Name	Company	Email
To	Michael Azar	Ecove	michael@ecove.com.au
	Charmaine Pang	Bates Smart	cpang@batesmart.com
	Andrew Brohier	McKenzie Group Consulting	abrohier@mckenzie-group.com.au
Date	04/04/2016	Job no SY150512	Version CA1.4
Project	Site 9 – Sydney Olympic Park

1. Introduction

We have prepared this advice to identify and document the fire safety measures that are likely to be required for the proposed residential tower development at Site 9, Sydney Olympic Park to achieve compliance with the performance requirements of the National Construction Code Series 2015 Volume One – Building Code of Australia (BCA)¹. This review is based on the documentation listed in Appendix A.

Figure 1 Ground floor retail fire separation

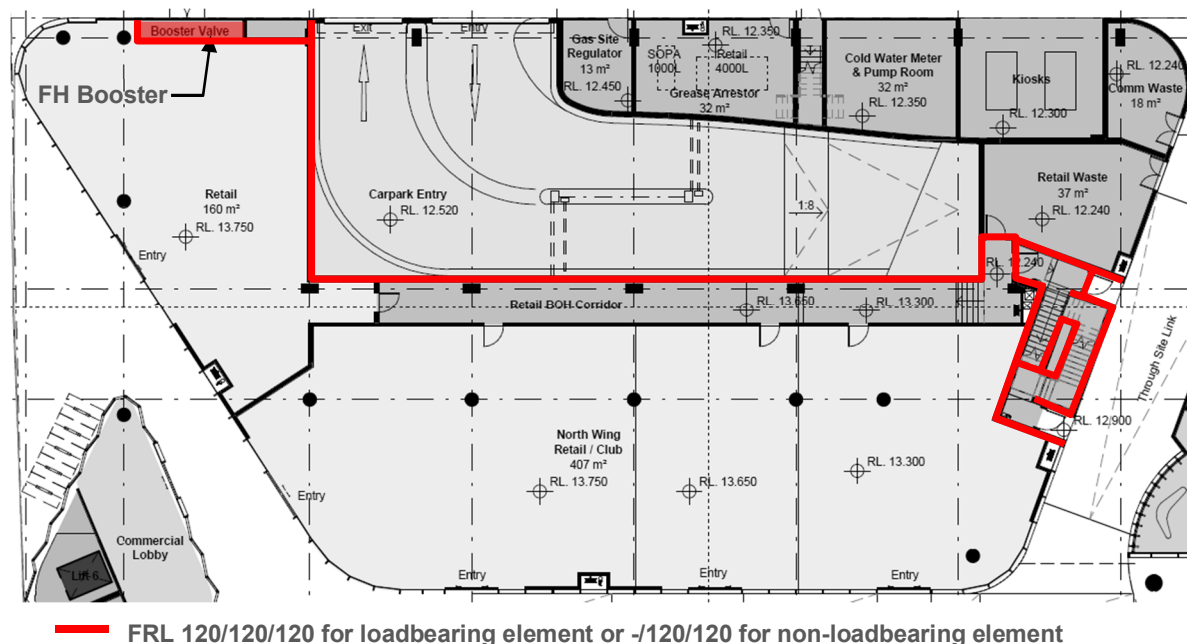
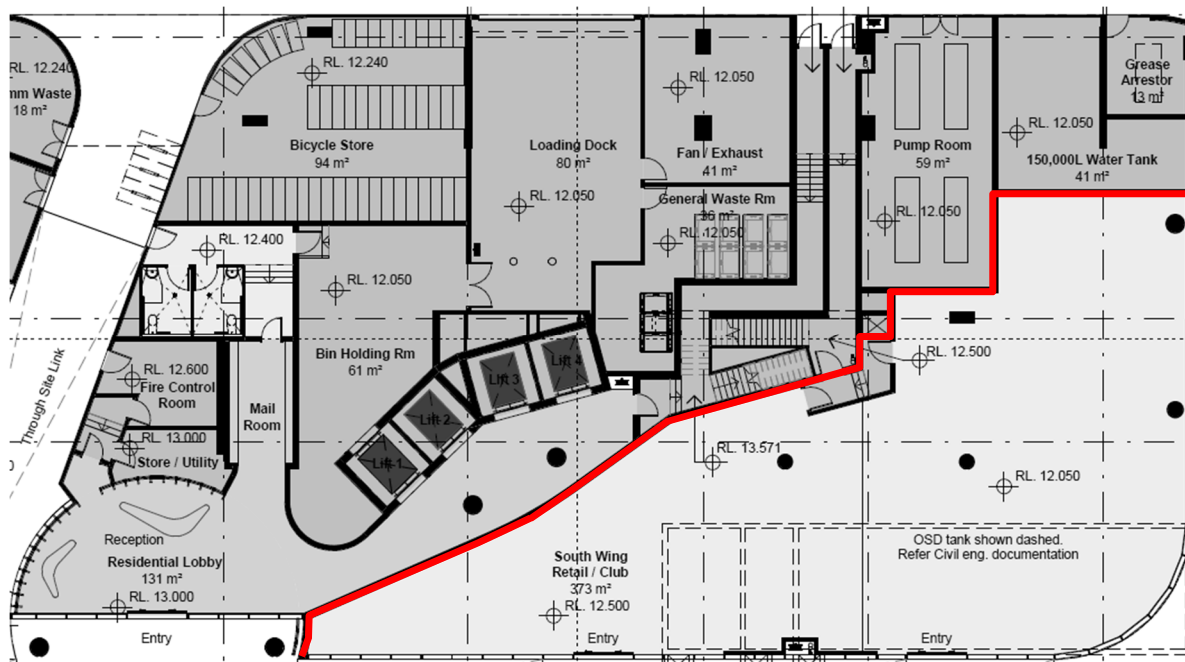
4. The retail areas on the ground floor must be separated from the other classifications on the storey by a fire wall and floor above that achieve an FRL of not less than 120/120/120 instead of 180/180/180 as required by clauses C2.7, C2.8 and C2.9 of the BCA. Refer to Figure 1.

— FRL 120/120/120 for loadbearing element or -/120/120 for non-loadbearing element

18. The proposed location of the fire hydrant booster assembly adjacent to the carpark entry as shown in Figure 1 is not considered comply with AS 2419.1-2005 as it is not within sight of the main entry to the building being the main residential entry lobby.
Note: The proposed location of the fire hydrant booster will need to be referred to FRNSW for approval.

Figure 2 Levels 7-9 and 36-38 maximum travel distance to a point of choice

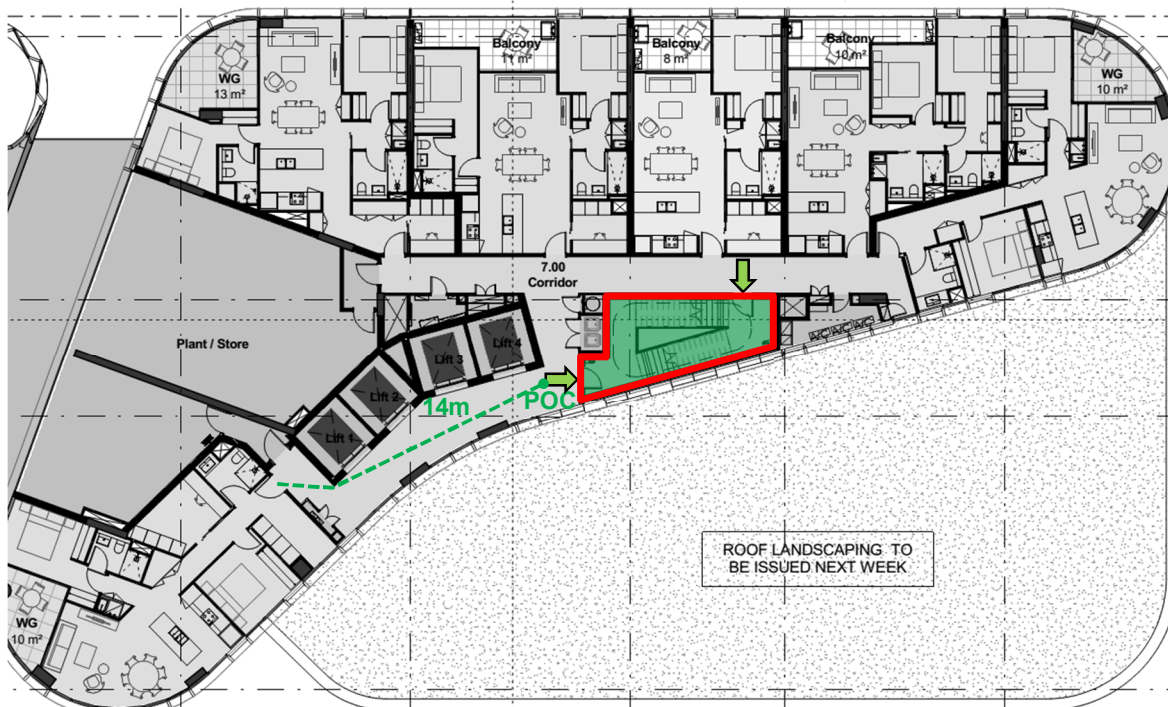
6. Each storey including the commercial portions on levels 7 and 8 must be served by a minimum of two fire-isolated exits in accordance with clause D1.2 of the BCA.
7. The maximum travel distance to a point of choice within the residential corridors may be extended to:
 - a. 14m instead of 6m from the furthest apartment on levels 7-9 and 36-38 provided occupants need not travel past another apartment before reaching a point of choice as shown in Figure 2.
 - b. 15m instead of 6m from the furthest apartment on levels 10-35 provided occupants need not travel past more than one apartment before reaching a point of choice as shown in Figure 3.

Figure 5 Maximum travel distance to nearest exit on commercial levels 7 and 8

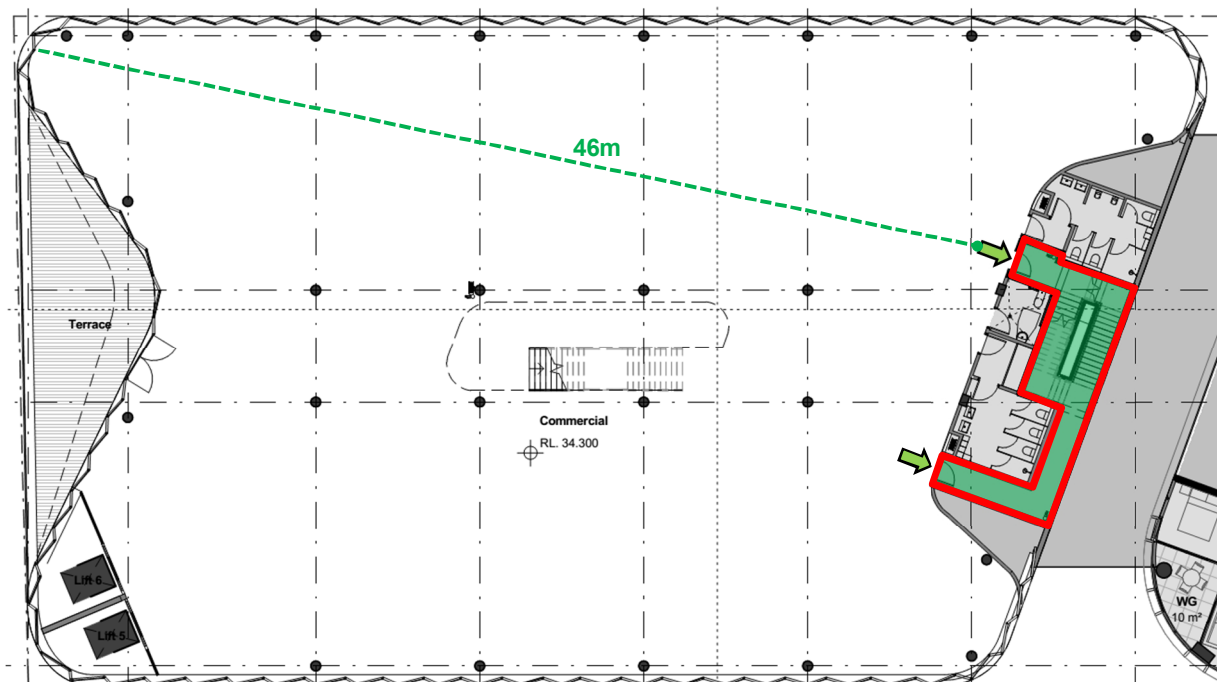
9. The following maximum travel distances apply within the commercial office levels of the building:
- 20m to a single exit or point of choice
 - 50m to the closest of two or more alternative exits including fitout
 - 60m between alternative exits.

Figure 6 Residential courtyard on level 9

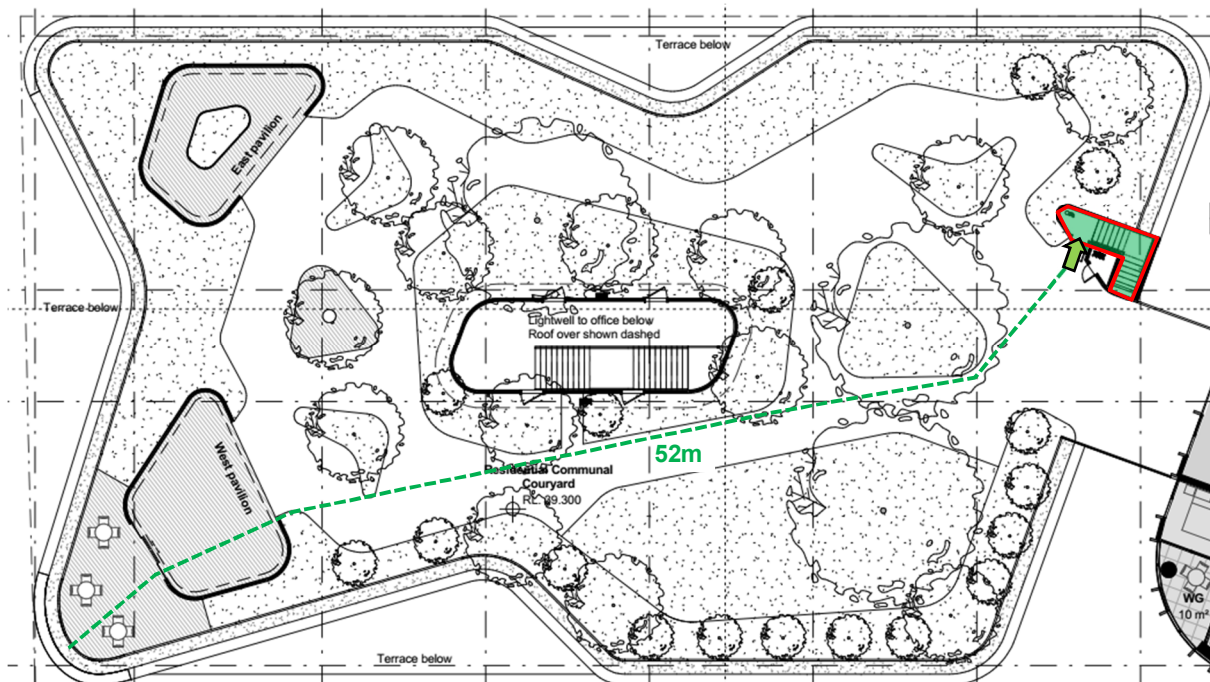
10. The maximum travel distance to the nearest exit from the residential courtyard on level 9 may be extended to 52m in lieu of 20m as shown in Figure 6 provided the following requirements are met:
- The floor of the roof must achieve an FRL of 120/120/120 in accordance with clause D2.12 of the BCA.
 - The courtyard is fully opened to the sky.
 - The sound system and intercom system for emergency purposes must be audible throughout the courtyard.

Figure 7 Discharge of fire isolated stairs into covered through site link

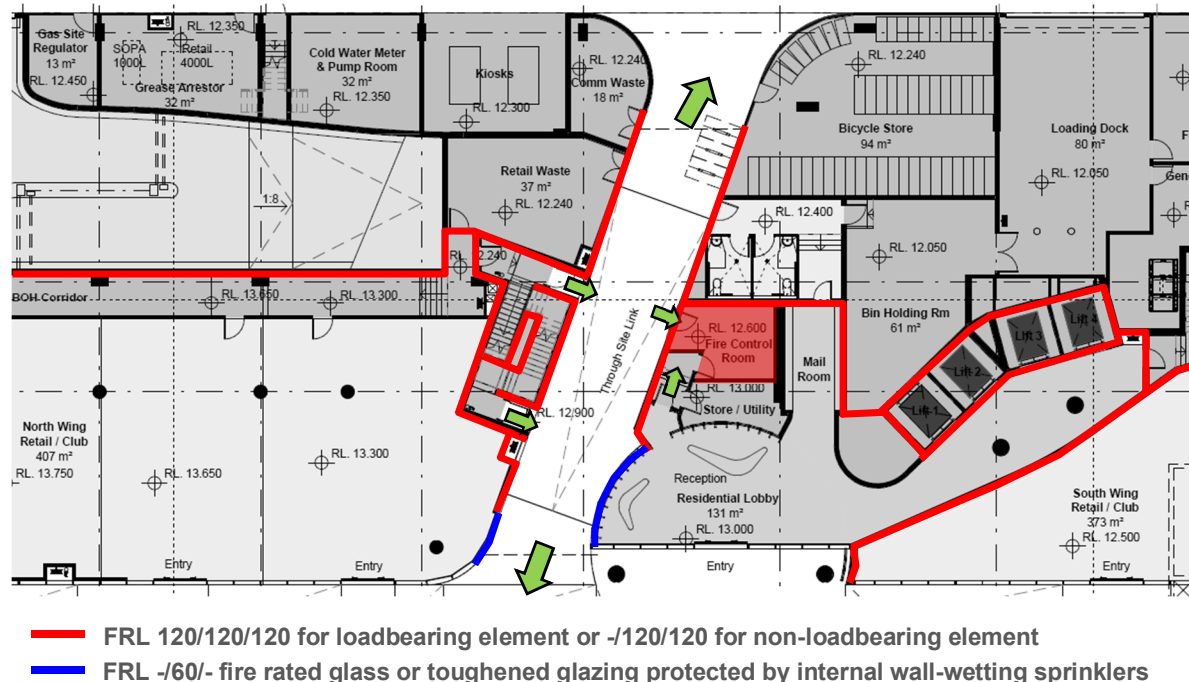
13. The two fire-isolated stairs serving the low rise portion of the building may discharge into the covered through site link which is not open for at least 1/3 of its perimeter provided the following requirements are met:

- Openings must have a total clear width of 9m comprising of the two openings at either end of the through link
 - Has an unobstructed clear height throughout, including the perimeter openings, of not less than 3m

- The internal walls bounding the through site link must achieve an FRL of 120/120/120 or -/120/120 if the walls are non-loadbearing
 - Glazing in the internal walls bounding the through site link is permitted provided it is FRL -/60/- fire rated glass or 10mm toughened glazing protected on the inside by quick response Tyco Model WS™ 5.6 K-factor pendent vertical or horizontal sidewall sprinkler heads

- Doorways opening into the through site link must be protected by self or automatic closing FRL -/120/30 fire doors

- f. The residential entry lobby must be fire separated from the bike store as shown in Figure 7
14. The maximum travel distance to a point of choice/nearest exit from the common area/room on level 9 may be extended up to 30m in lieu of 20m.

19. The building is required to be provided with a fire control room in accordance with clause E1.8 of the BCA. The fire control room is proposed to be accessed via the through site link and the residential entry lobby as shown in Figure 7.
Note: The proposed location and access to the fire control room will need to be referred to FRNSW for approval.
